RE: **Addendum No. 1/City of Mission Event Center**
Request for Proposal No.: 17-010-11-29

ADDENDUM 1

Date: 11-16-2016
Project: Mission Event Center
Project No.: 2016-01

SHEET NO.
A-1
1 of 10

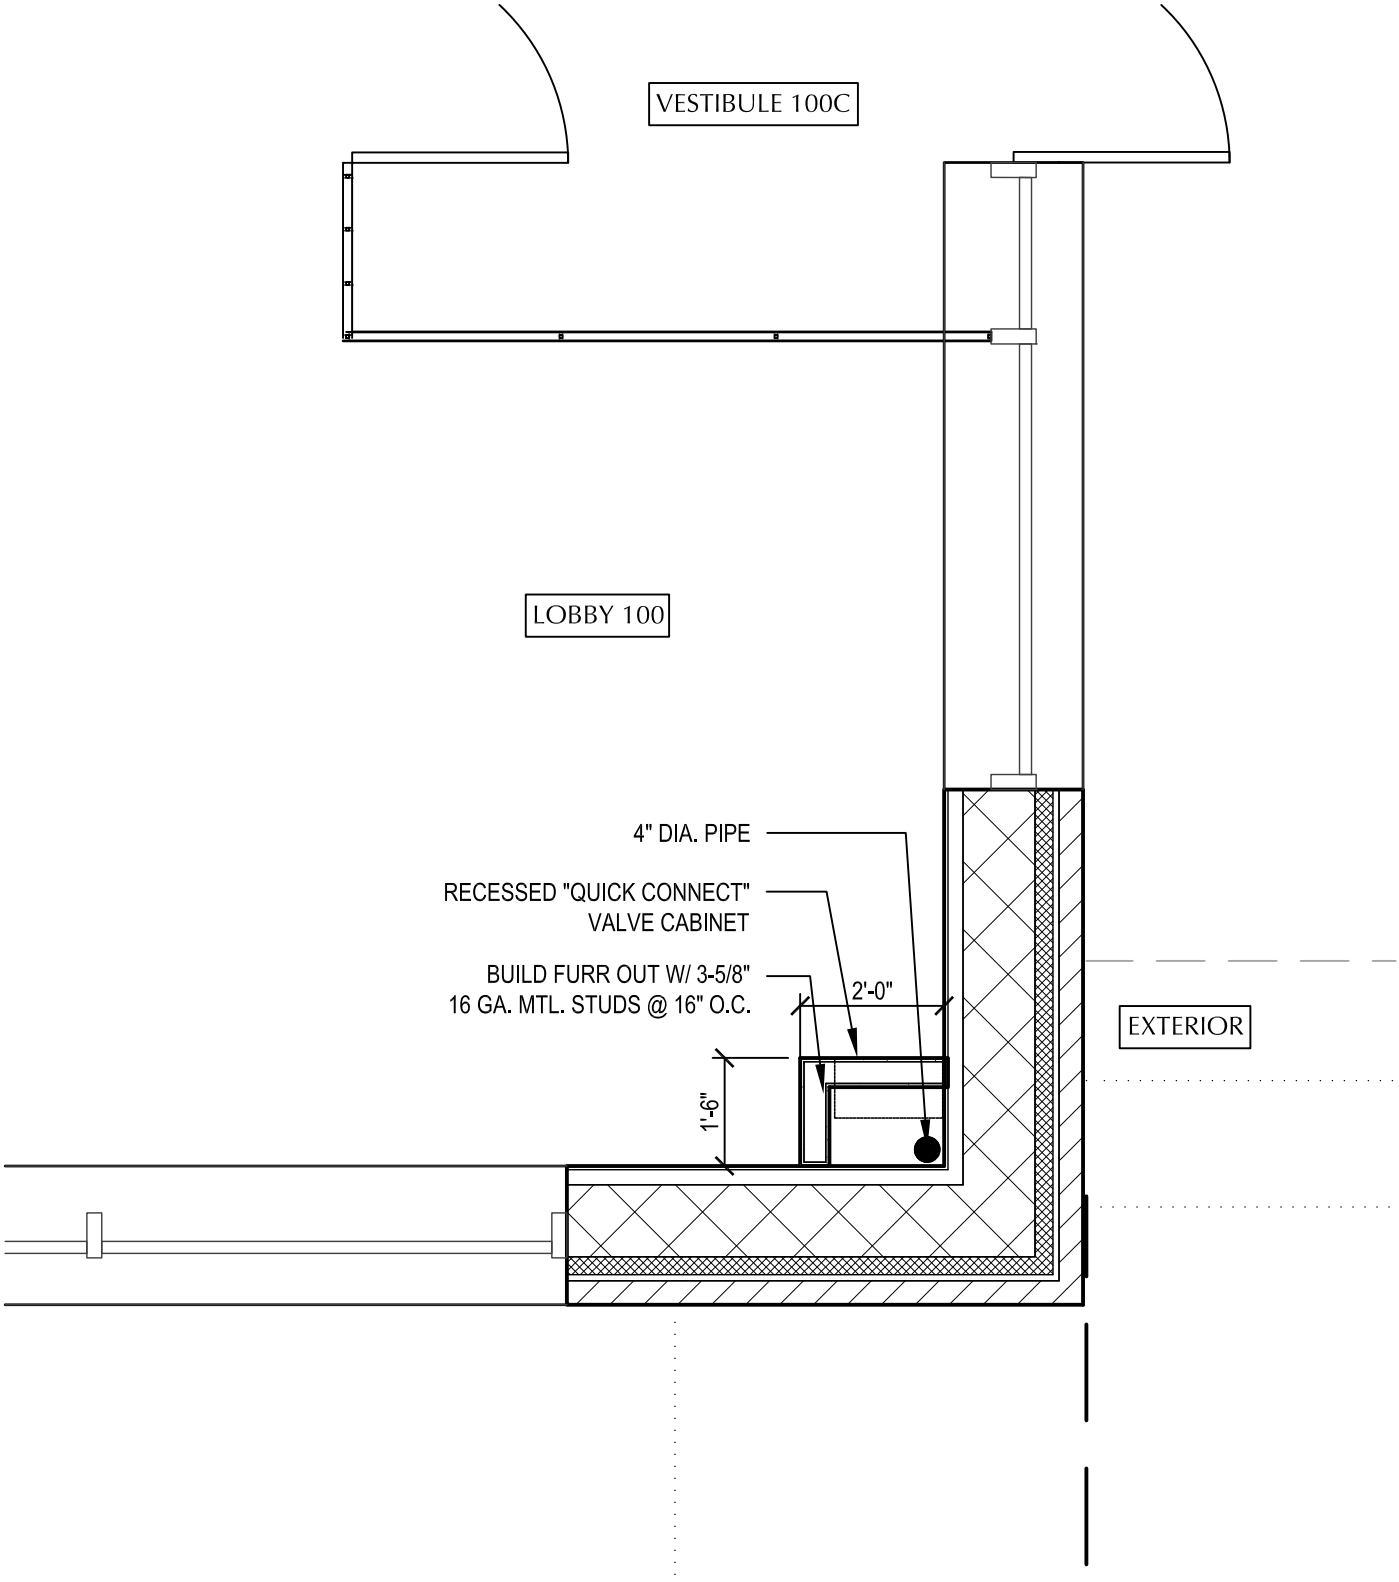
2. *Modification*: A General Contractor shall construct furr out in the corner of the lobby, Salon "G" (East Wall) and Corridor #127 to conceal the pipe and install recessed "Quick Connect" valve cabinet. Furr out will be built using 3-5/8" 20 Gauge metal studs at 16" on center and 5/8" Gypsum Board, painted. Refer to **Sheets A-1, A-2 & A-3** attached for specified location of furr outs.

SHEET NO.
A-4

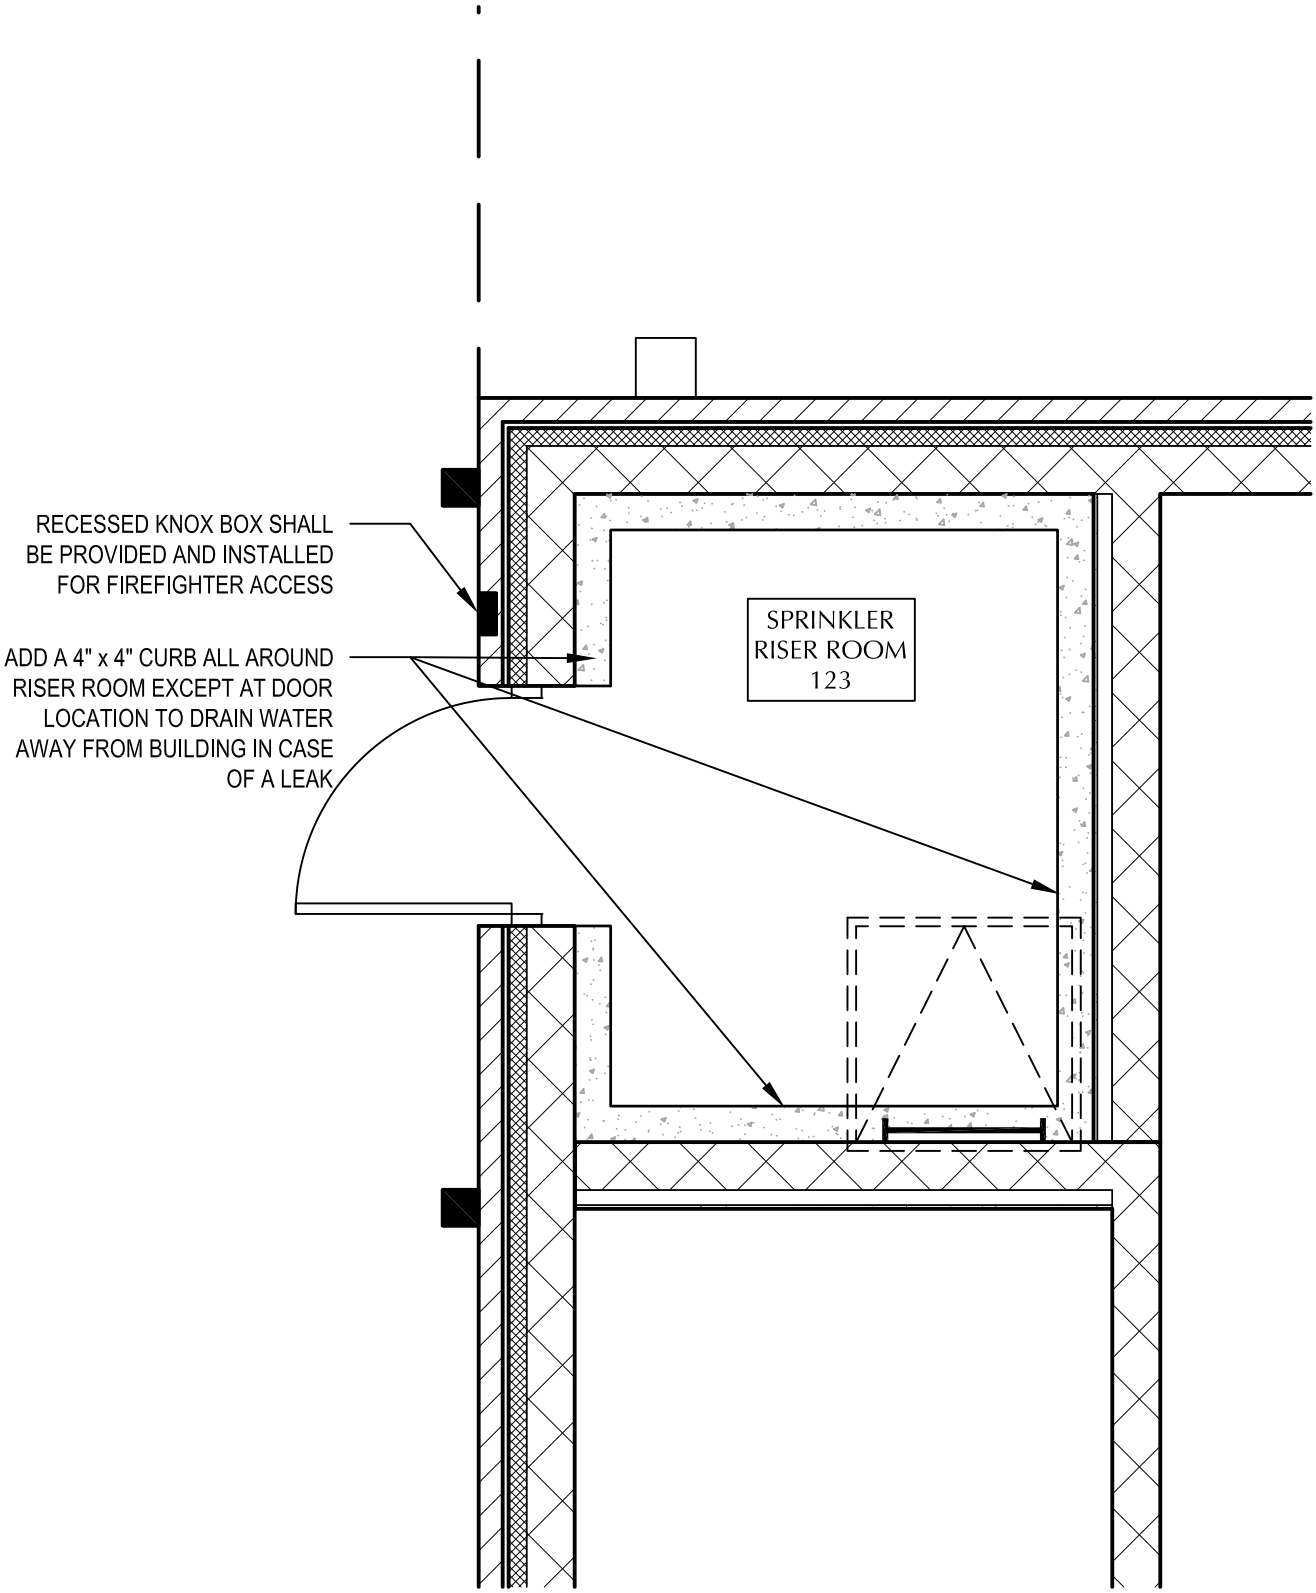
3. *Modification:* A recessed knox box adjacent to the door 123 of the sprinkler riser room shall be provided and installed for firefighter access. Refer to Revised floor plan **Sheet A-4** attached herewith.

4. *Modification:* Add 4" x 4" concrete curb in all the walls in the Riser Room except at door location. This will ensure any water will drain beneath the door towards the outside in the event of a leak in the fire riser room. See revised **Sheet A-4** attached for location of concrete curb.

SHEET NO.
A-5
5 of 10

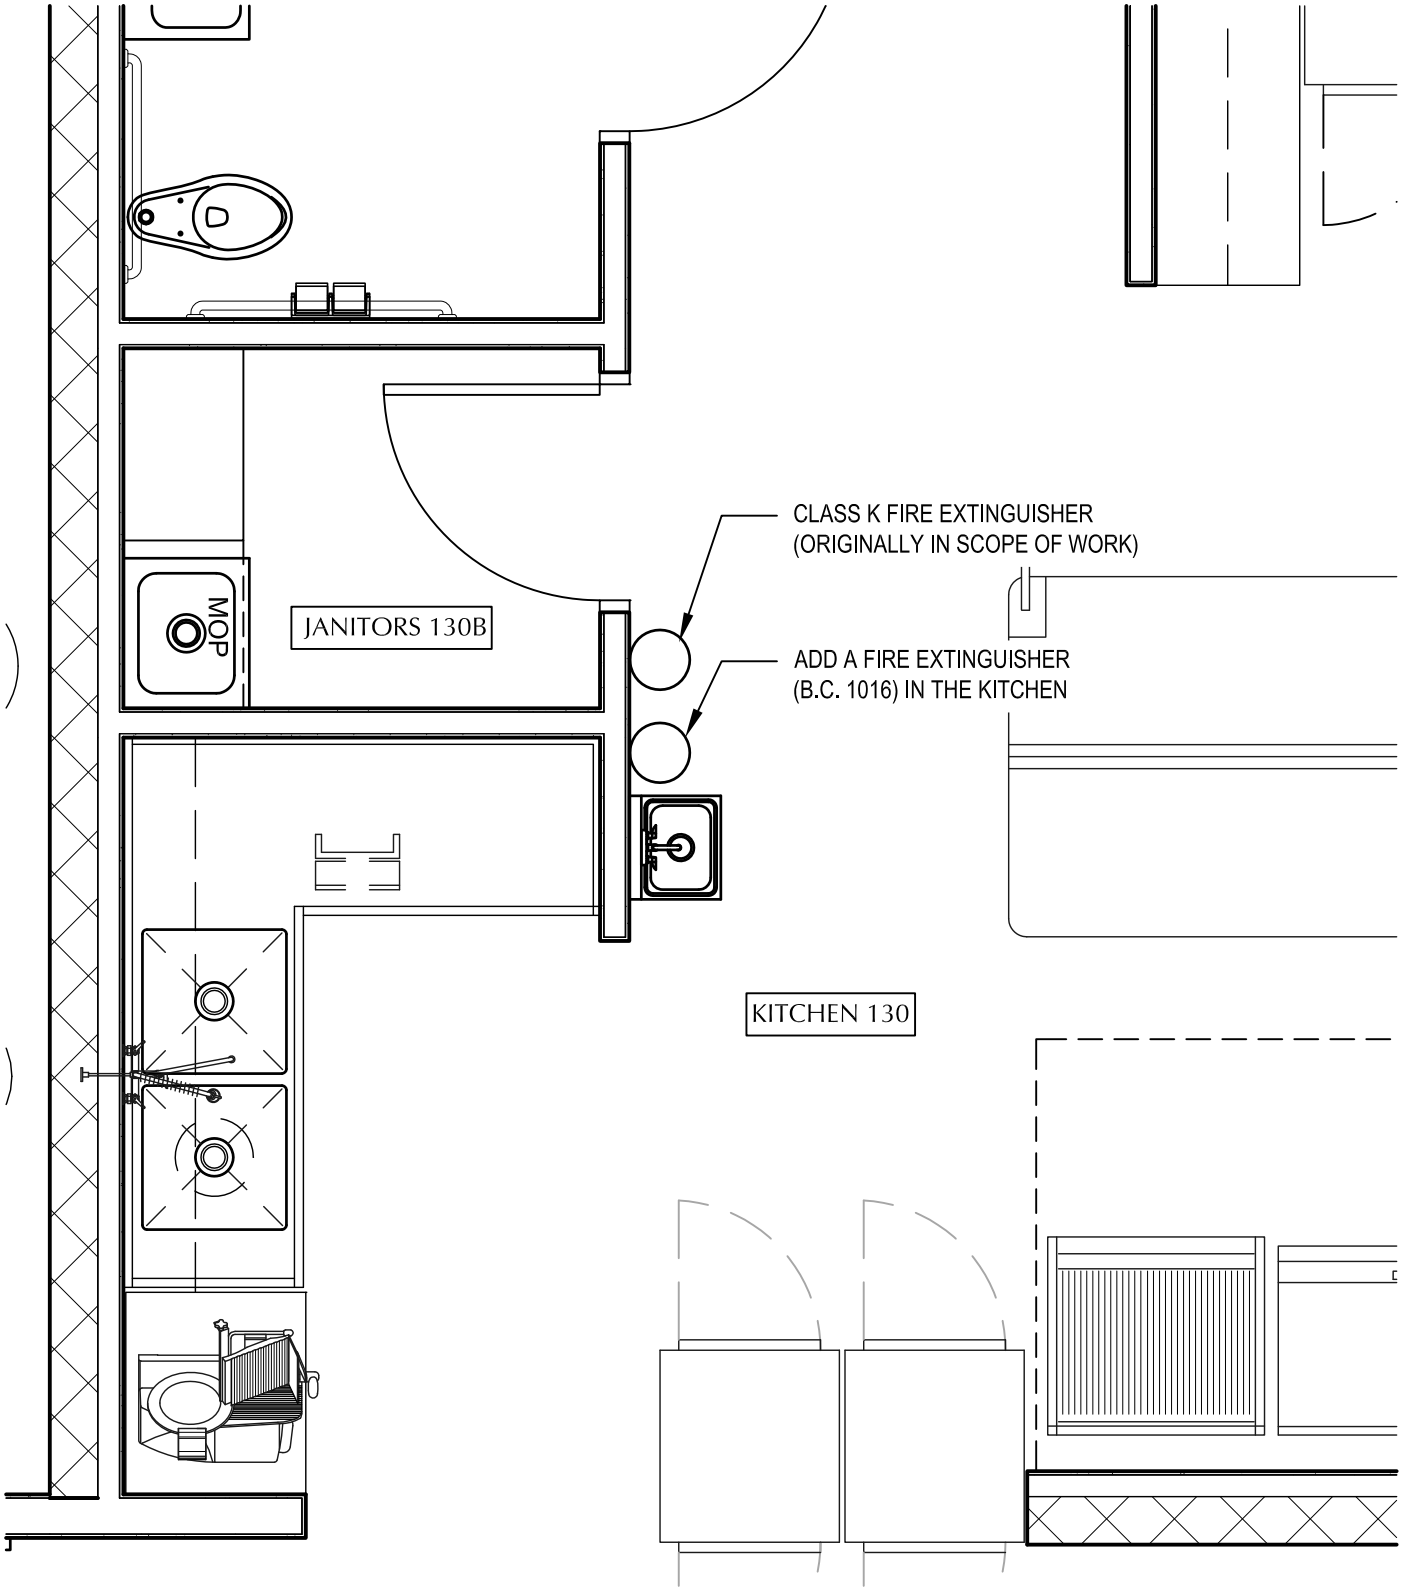
5. *Modification:* Add fire extinguisher to kitchen (B.C. 1016 fire extinguisher) next to existing. Refer to revised **Sheet A-5** attached.

SHEET NO.
A6
6 of 10

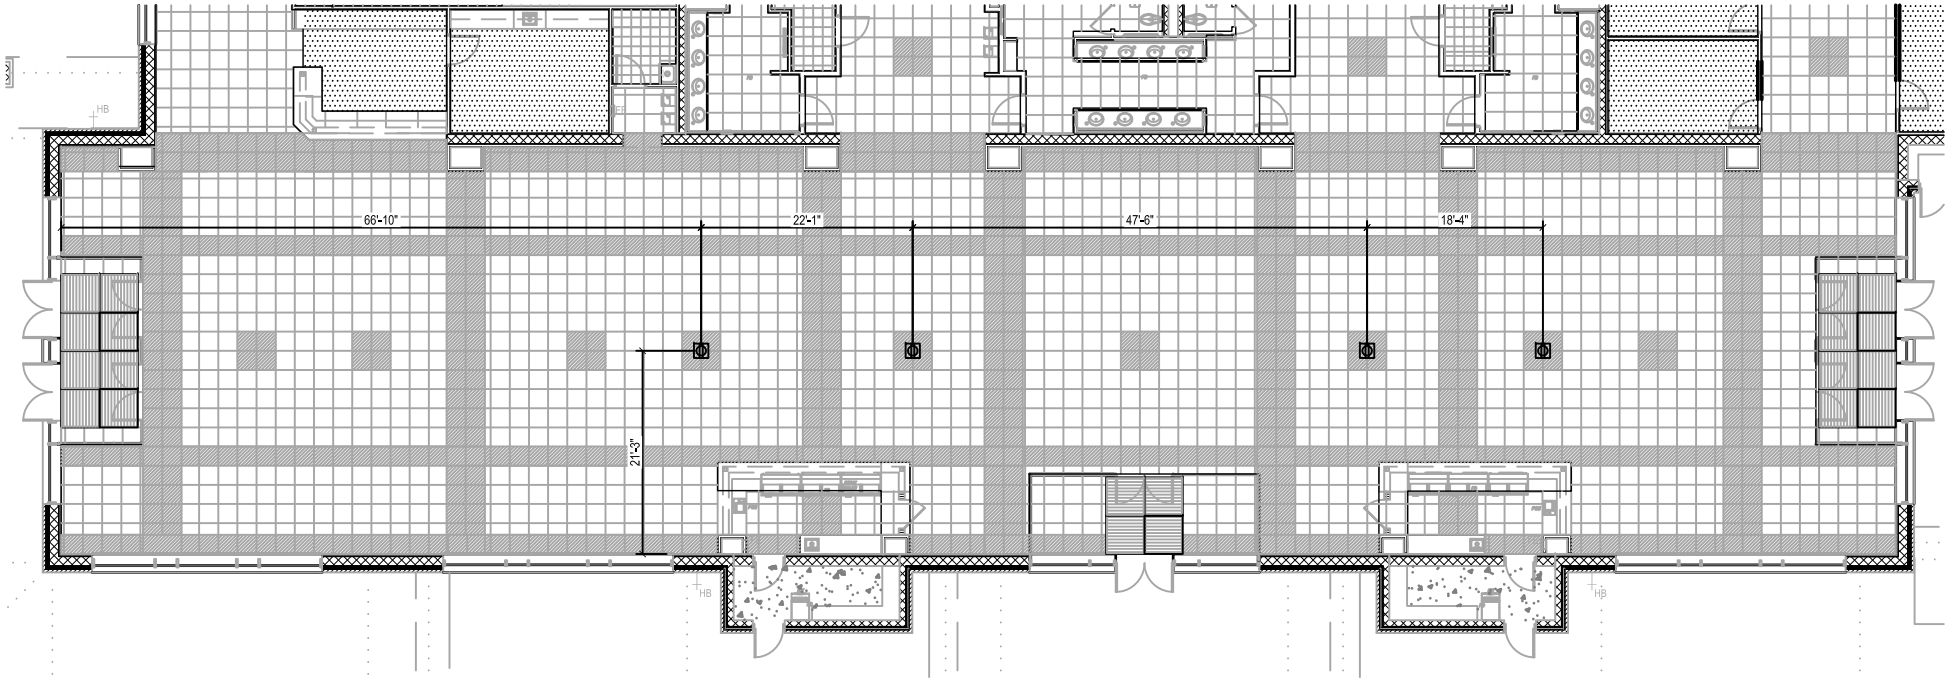
6. *Modification:* There will be four (4) new floor receptacles, recessed and flush, added to the lobby in specified locations. Cover color to be bronze. Refer to Revised **Sheet E1.2** and Architectural **Sheet A-6** attached for locations of new floor receptacles.

SHEET NO. A-7

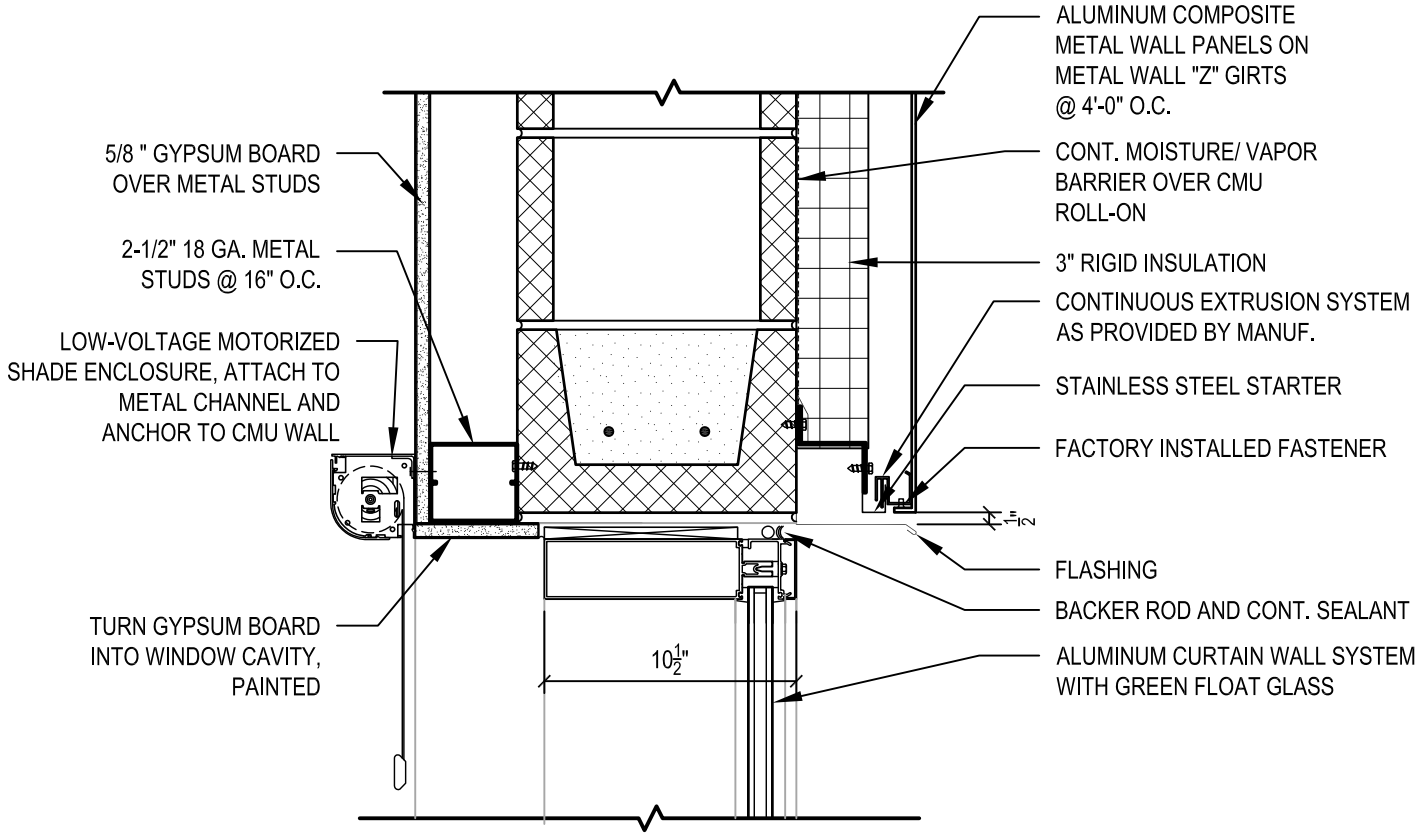
12. *Clarification:* Window frame will be inset on CMU where metal wall panels meet window frame. Refer to revised Details on **Sheet A-7 & A-8** attached herewith.
